Administrative Subdivision Plan #620170070
8911 & 8915 BURDETTE ROAD
Lot 13 & Part of Lot 17, Block B / Tax Map GP341, WSSC Grid #211NW07
Bradley Hills Grove
ELECTION DISTRICT #07
MONTGOMERY COUNTY, MARYLAND

RE: Administrative Subdivision Plan
No. 60170070
8911 & 8915 Burdette Road

RE: 8911 & 8915 Burdette Road
Administrative Subdivision
Plan No. 620170070

Re: **COMBINED STORMWATER MANAGEMENT
CONCEPT/SITE DEVELOPMENT
STORMWATER MANAGEMENT PLAN** for
Bradley Hills Grove, 8911 and 8915 Burdette
Road
Preliminary Plan #: 620170070
SM File #: 283064
Tract Size/Zone: 2.61 ac
Total Concept Area: 2.61 ac
Lots/Block: Bradley Hills Grove Lot 13 and Part
of Lot 17, Block B
Parcel(s): N/A
Watershed: Cabin John Creek

Preliminary Forest Conservation Plan #620170070
8911 & 8915 BURDETTE ROAD
Lot 13 & Part of Lot 17, Block B / Tax Map GP341, WSSC Grid #211NW07
Bradley Hills Grove
ELECTION DISTRICT #07
MONTGOMERY COUNTY, MARYLAND

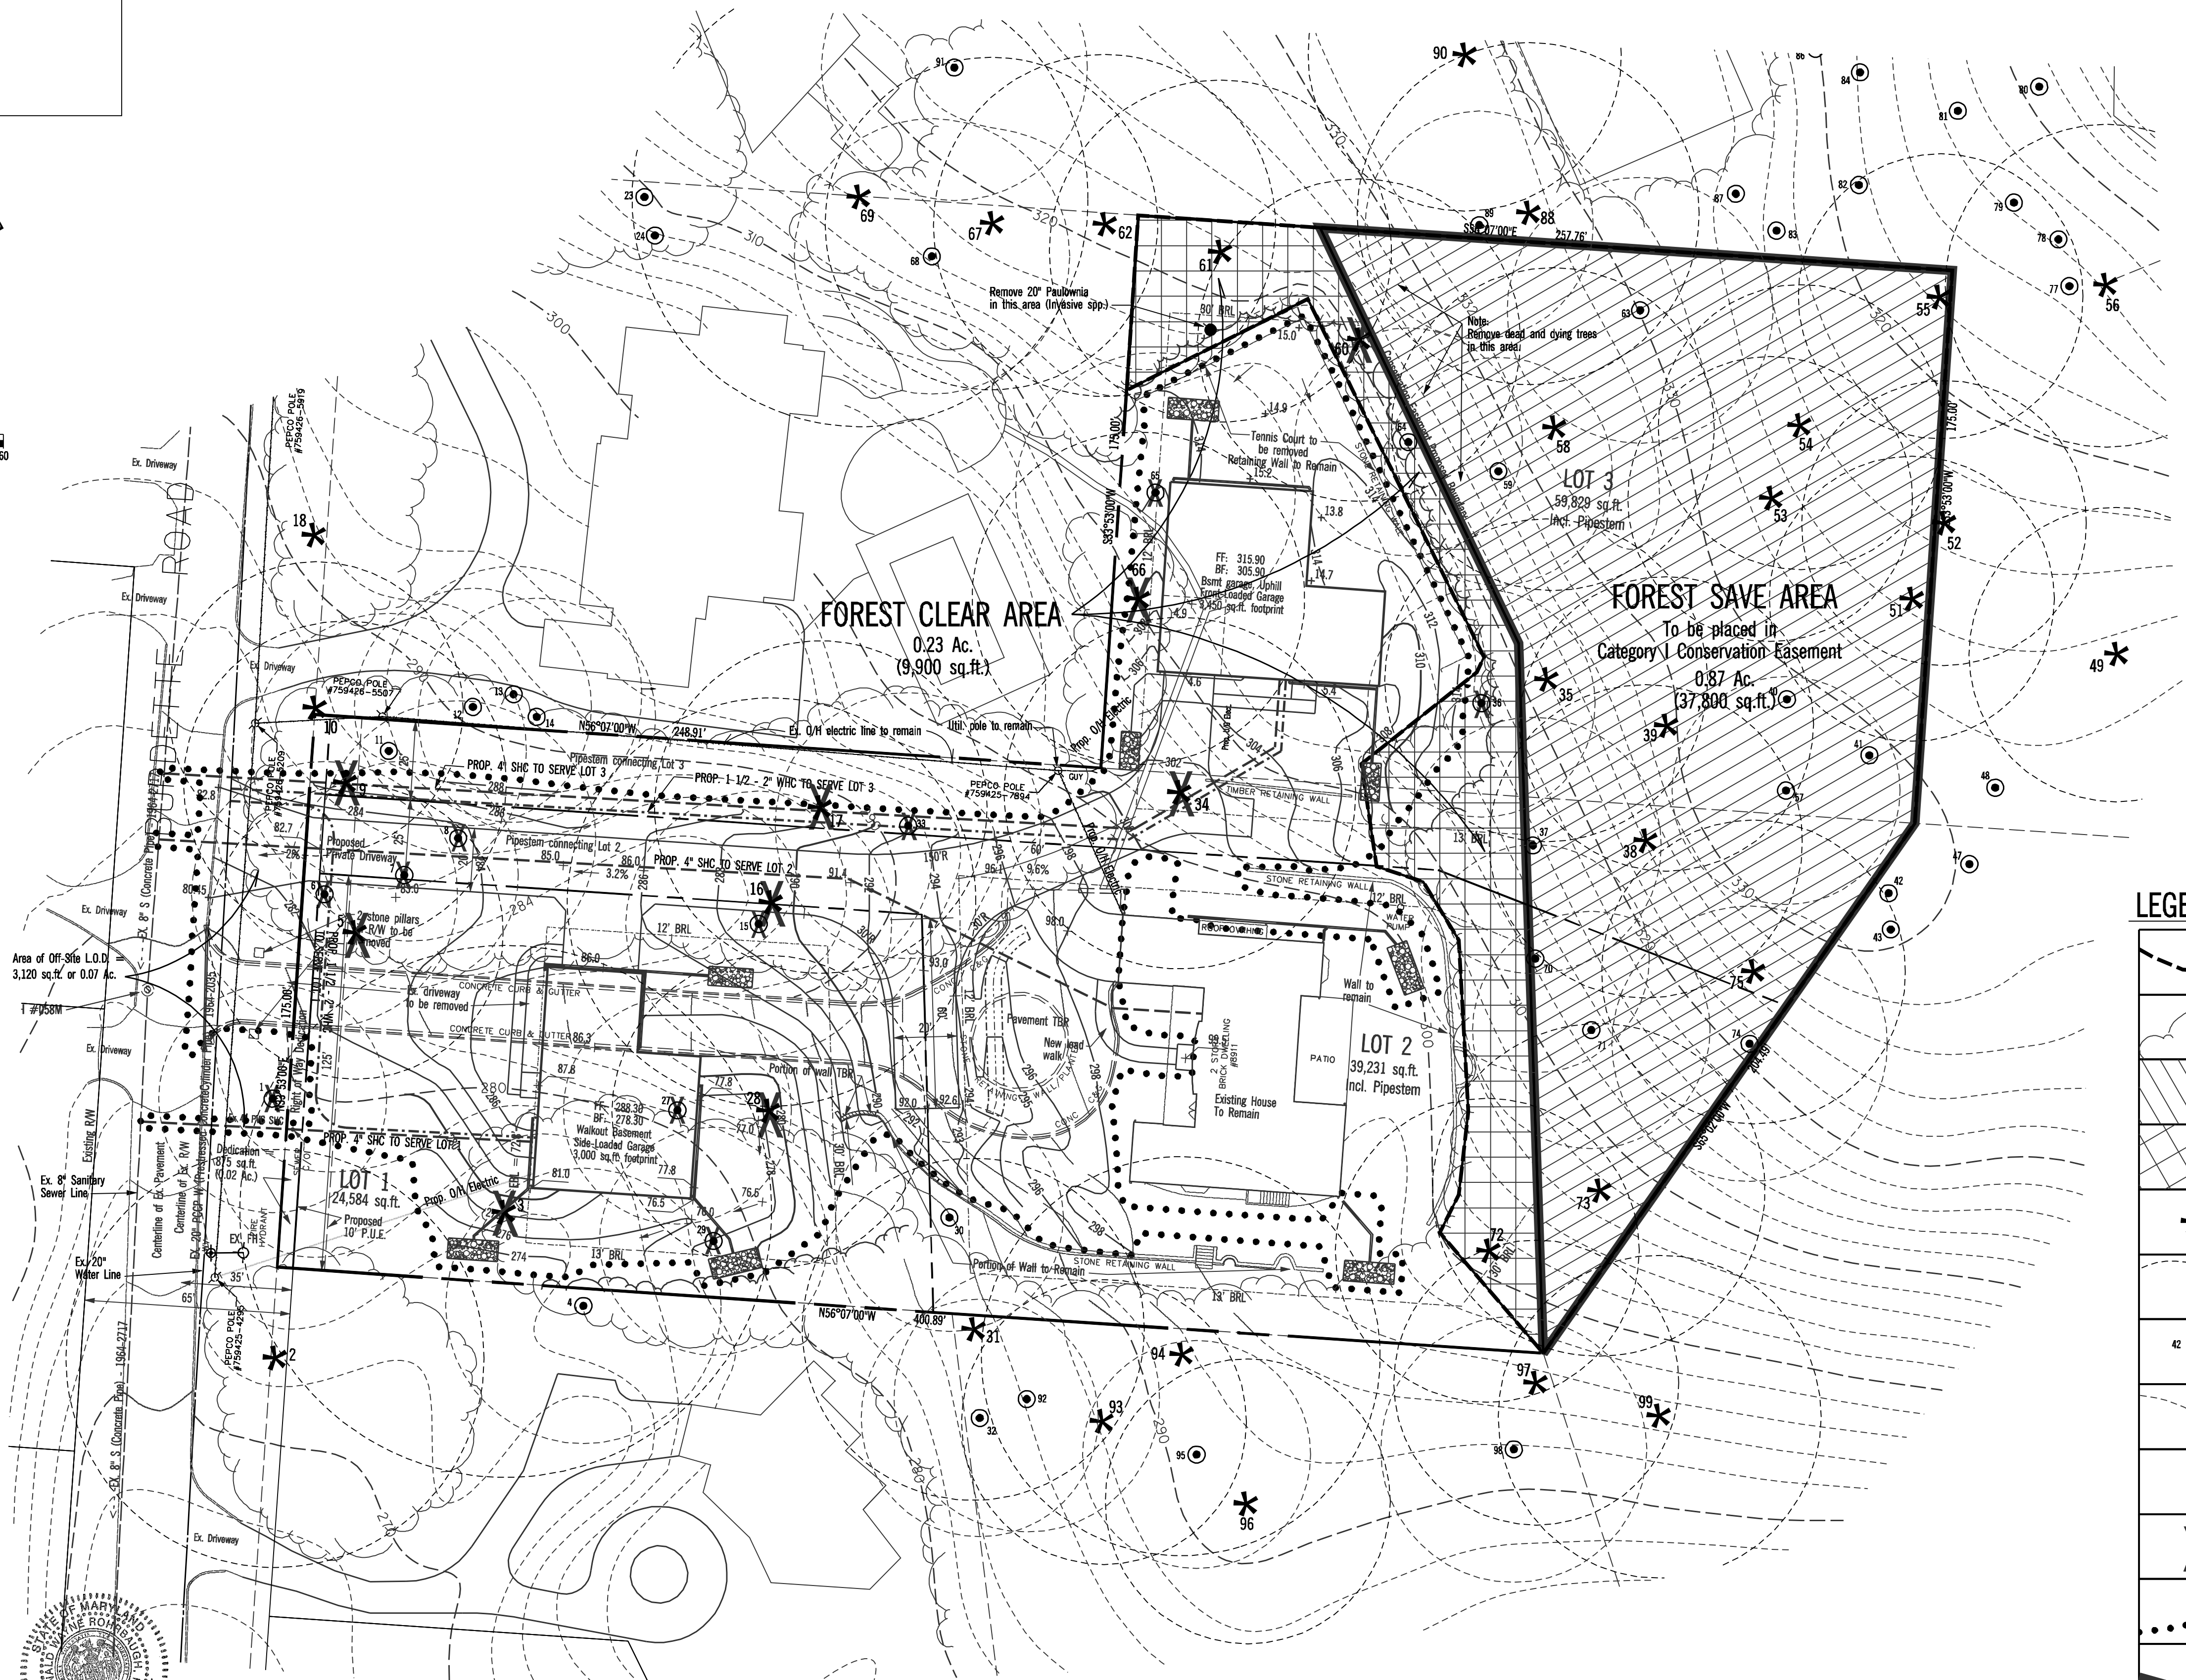
NO	REVISION	DATE
3	Revise per M-NCPPC staff comments	4/13/18
2	Revise per review comments	2/14/18
1	Revise per DRC comments	11/29/17

Preliminary Forest Conservation Plan #620170070

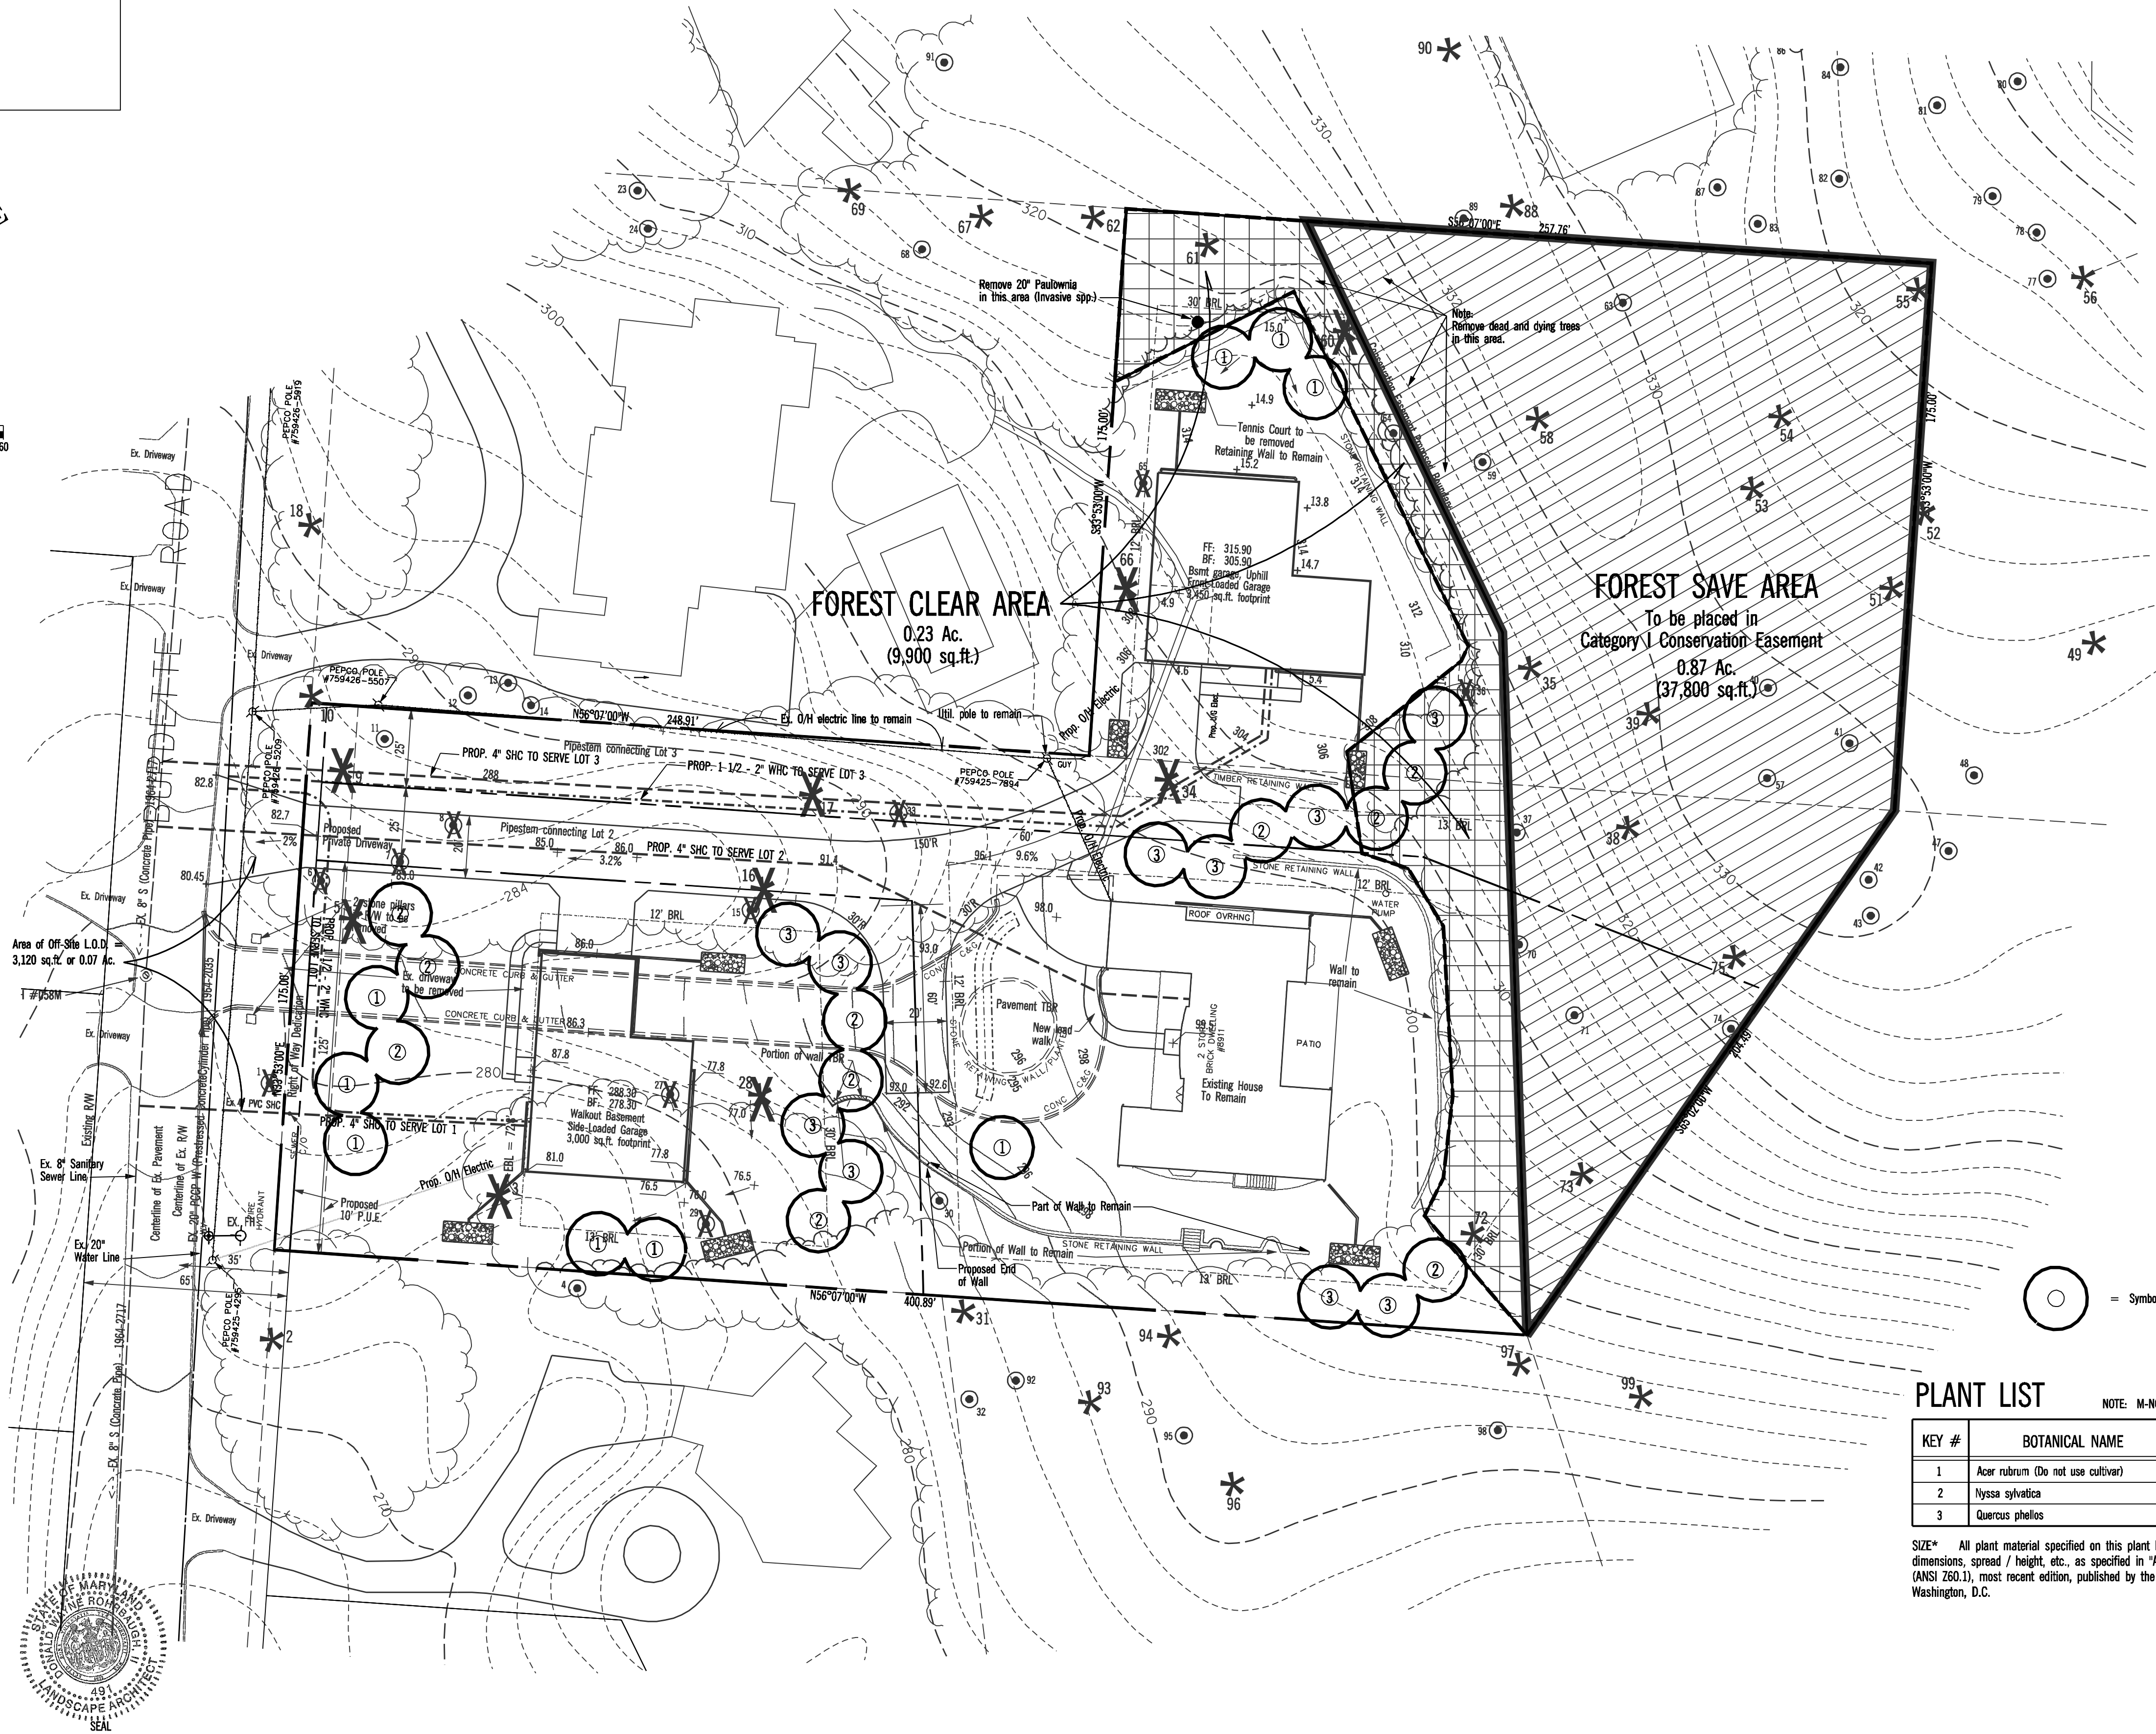
3	Tree #58 not impacted - impact designation removed from tree list	4/13/18	
2	Revise per review comments	2/14/18	
1	Revise per DRC comments	11/29/17	
NO	REVISION	DATE
